HFI DEVELOPMENT INC
QUASIJUDICIAL FILE

TO: Planning & Zoning Board
FROM: Scott Pickett, ^{SP} Acting Planning & Zoning Director
SUBJECT: HFI DEVELOPMENTS INC.: SITE PLAN AMENDMENT APPLICATION

REQUEST: The applicant requests site plan amendment approval to
develop a drive-thru facility exiting onto Wake Island
Road and to make changes to the approved building
addition.

RE: HFI, Inc. Development Site Plan Review

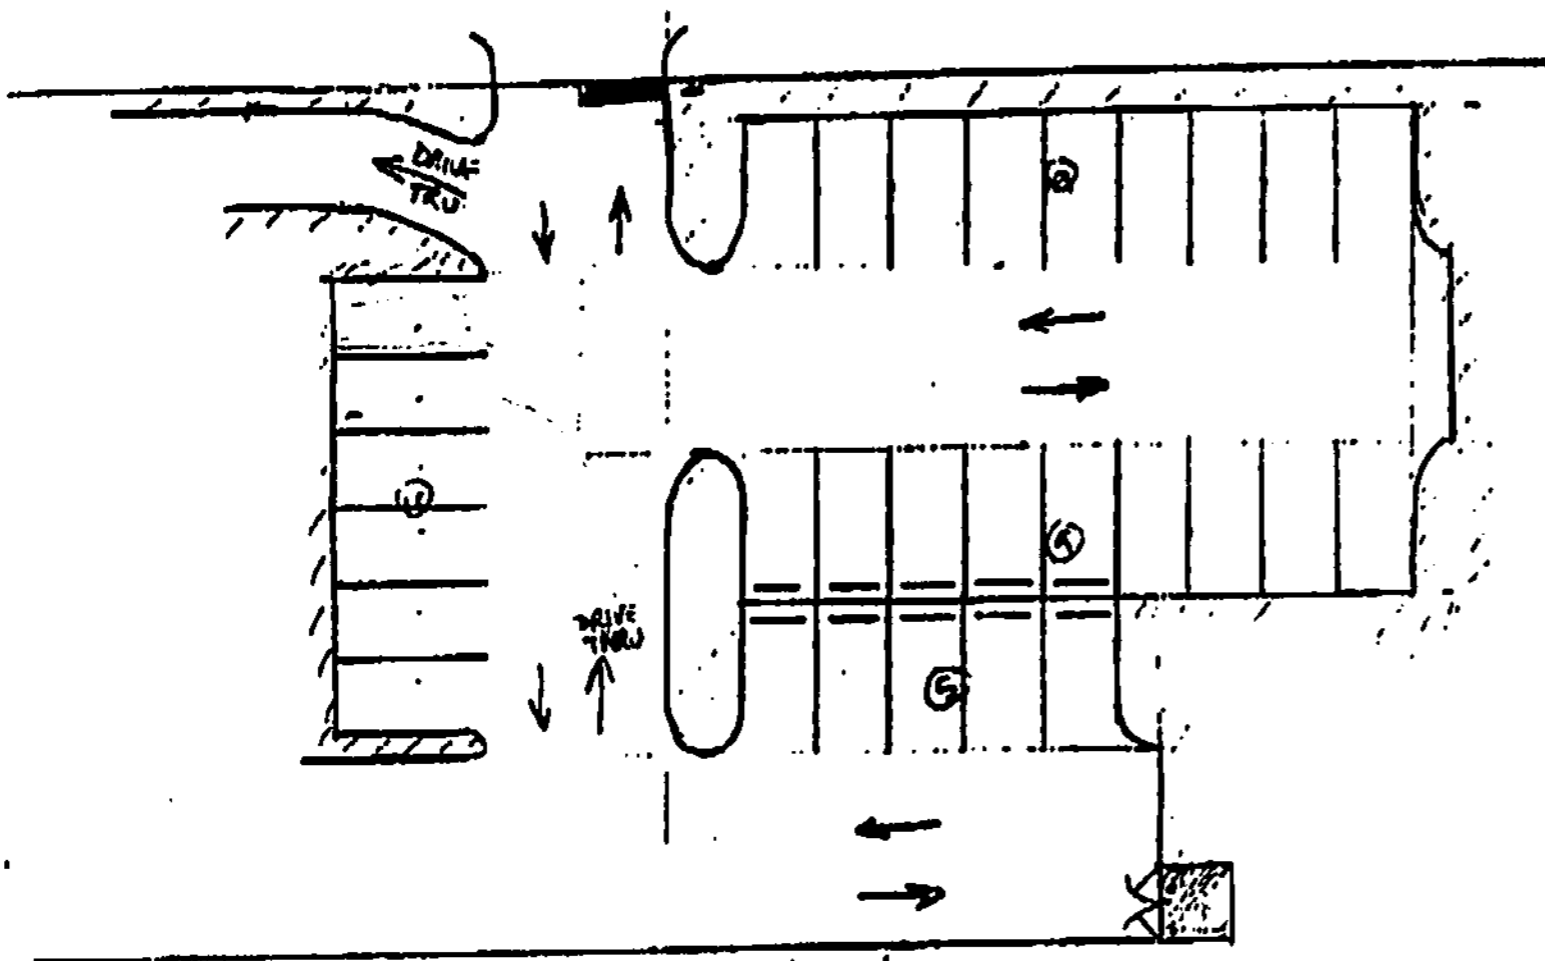
1. Both entrances to Gulf of Mexico Drive do not appear to provide adequate turning radiuses for northbound vehicles entering. Entering vehicles will cross the centerline creating an unsafe condition for both areas entrances.

4. The eastern parking entrance on Wake Island Road does not provide facilities for storm water flows across or under the entrance.

5. The drive-thru entrance does not provide adequate protection between adjacent parking stall and to the future Wake Island Road extension. Drive-thru vehicles will have a maximum overhang of approximately three feet that will extend into the right-of-way of Wake Island Road and the oncoming future traffic condition. Curbing has been provided for Wake Island Road vehicles and not for the drive-thru vehicles. Supporting documents discuss the use of curbing to channel vehicles on roadways. The unsafe condition will be from the overhang of vehicles in the drive-thru. No channelization control has been provided for the drive-thru vehicles.

Recommendation: Increase turning radius for both entrances to provide safe traffic access.

Recommendation: Add two-way traffic flow arrows to encourage traffic to exit through site entrance as well as to Wake Island Road. Label the arrows as painted and rotate drive-thru note.

Recommendation: Add culvert or provide grading of driveway accommodating the stormwater flows.

Recommendation: Provide median and curbing on both sides of drive-thru with sufficient width to accommodate large vehicle access and provide protection of the parked vehicle and oncoming traffic on Wake Island Road. This layout will require eliminating one parking stall adjacent to the drive-thru. Re-orientation of the parking lot can make up for the loss based upon preliminary layout sketches.

ILLUSTRATION OF DRIVE-THRU FACILITY PROPOSED AND RECOMMENDED IMPROVEMENTS

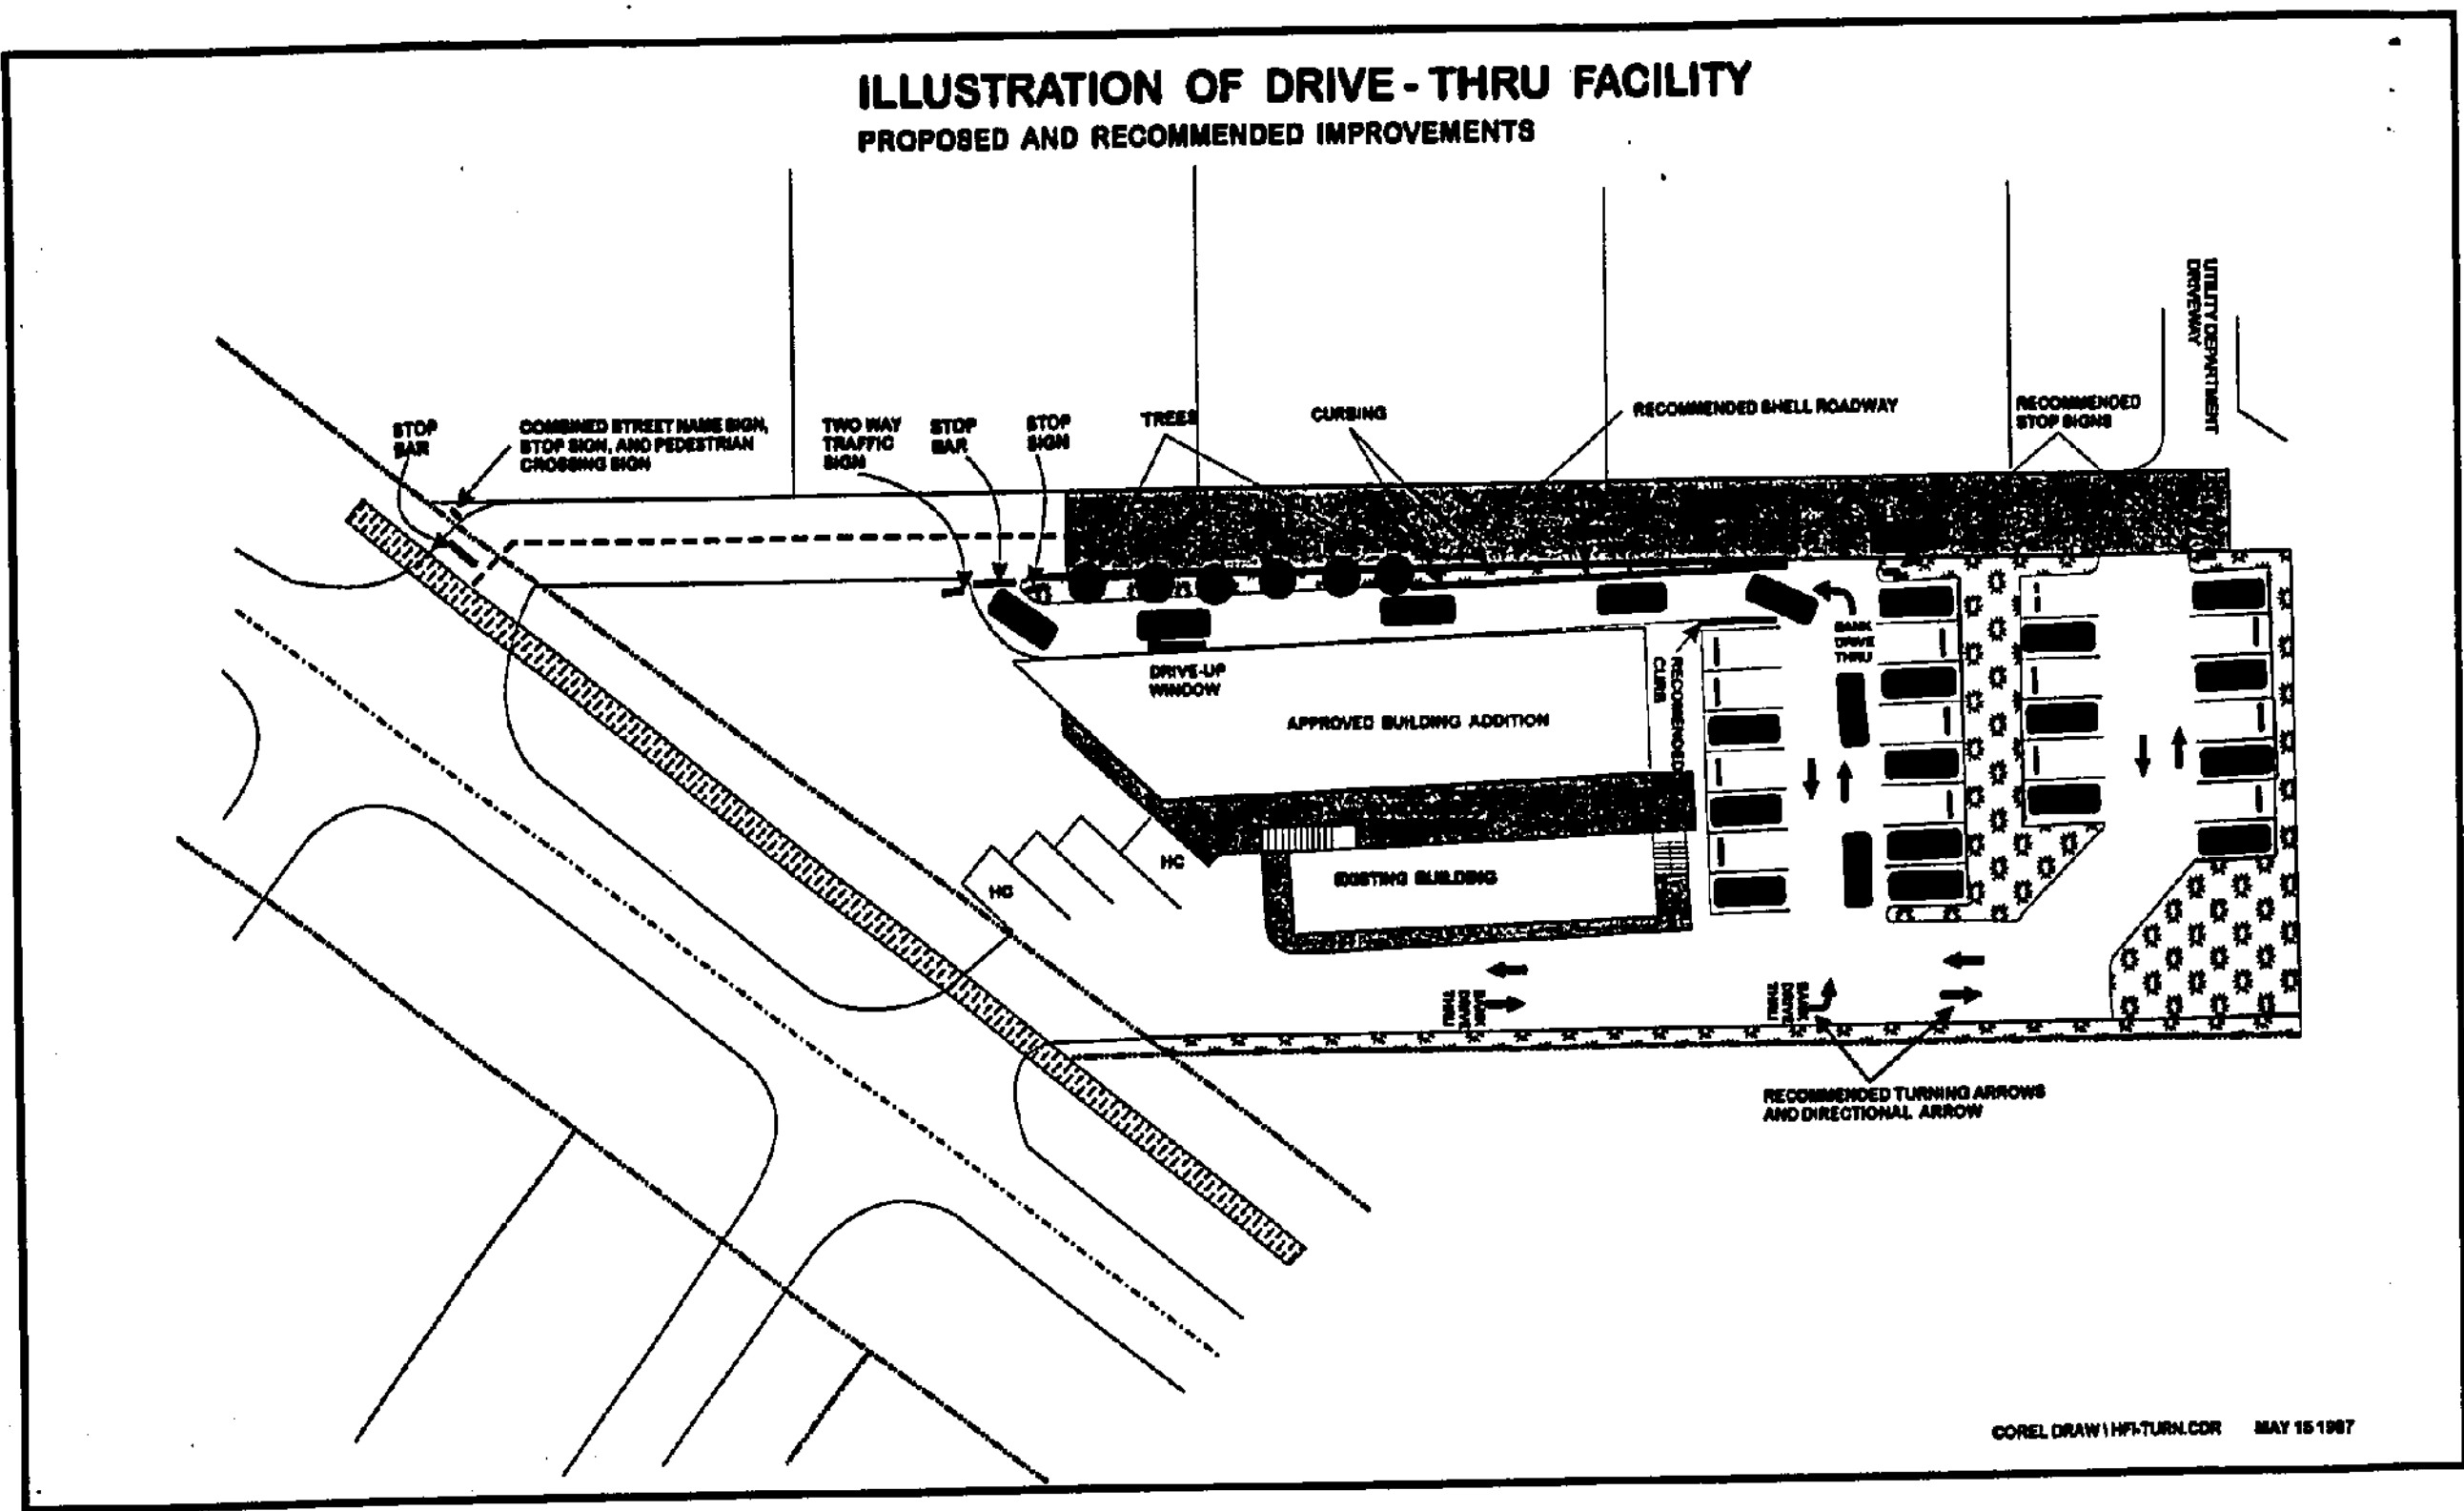
The attached staff-prepared illustration of the proposed drive-thru facility shows several additional recommended traffic information/control improvements that will further facilitate safe and convenient traffic circulation within the subject property as well as safe and convenient ingress and egress into/out of the subject property from Wake Island Road. Recommended improvements include stop signs at the intersection of Wake Island Road and the exits of both rear parking areas, revised drive-thru directional painted information within the parking area aisle, and additional two-way directional arrows painted within a parking area aisle.

- 14) The applicant shall be required to construct those proposed and staff recommended improvements indicated on the attached site plan drawing, titled "Illustration of Drive-Thru Facility", dated May 15, 1997.
